SPP Staff appreciates the opportunity to provide input regarding the Draft Congestion Study. The following remarks have not been vetted with SPP members, and do not represent any approved official remarks on behalf of SPP's members.

SPP Frequently Congested Areas

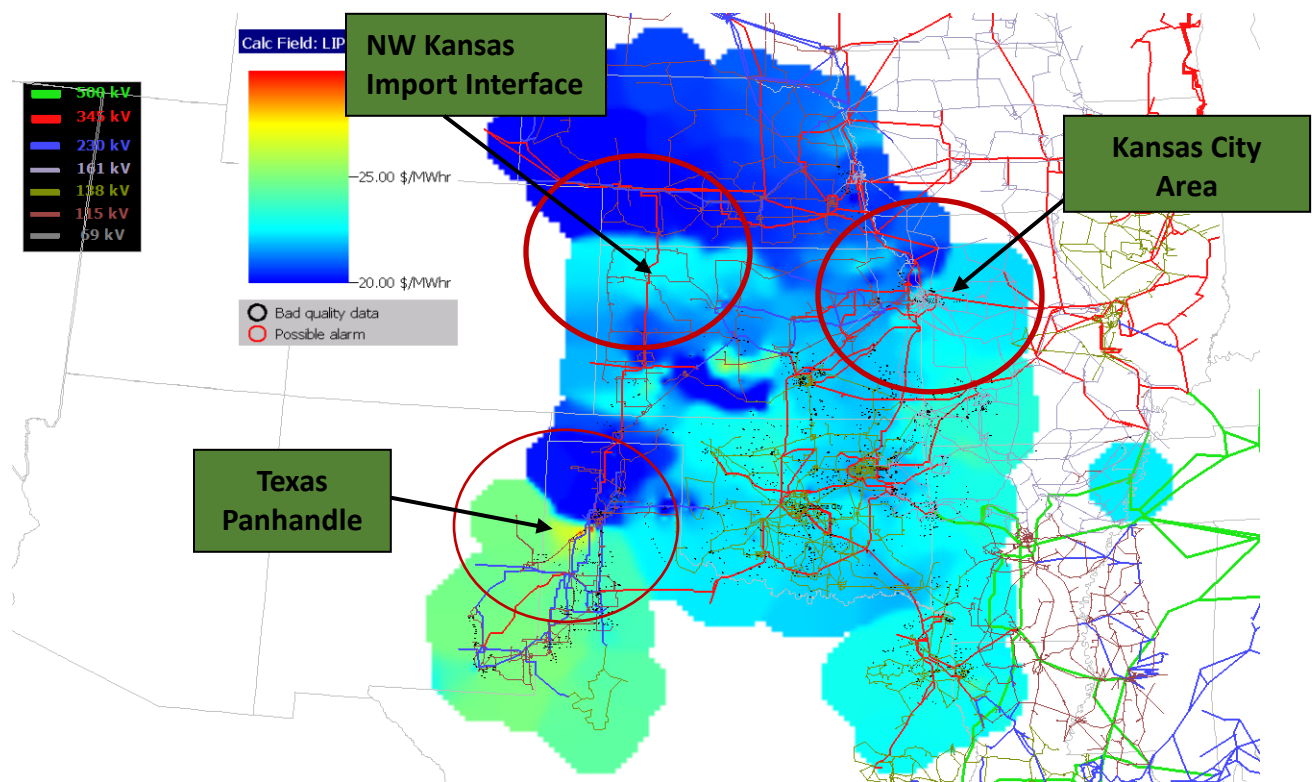
The bulk power system is very dynamic and congestion patterns are constantly changing as a result of load patterns, generation and/or transmission outages as well as new facility additions. SPP identified three Frequently Constrained Areas (FCAs) prior to the start of the SPP Integrated Marketplace on March 1, 2014. SPP, at the FERC's direction, applies more stringent energy market mitigation processes in the FCA relative to the rest of the SPP footprint. Figure 1 identifies the three areas. The study performed by Potomac Economics relied on 2011-2012 data from SPP's real-time energy imbalance market and can be found at <http://www.spp.org/publications/BODAGD&BKGD121013.pdf>.

SPP is currently studying the impacts of transmission upgrades during 2013 and 2014, as well as impacts from the implementation of the SPP Integrated Marketplace and consolidation of the footprint into a single balancing authority.

SPP has also reported that sixty percent (60%) of the auction revenue rights on paths into the frequently constrained areas have been allocated, comparable to a 90% allocation percentage on paths in other areas of the footprint. An auction revenue right is an instrument that allows the holder to acquire a financial transmission right.
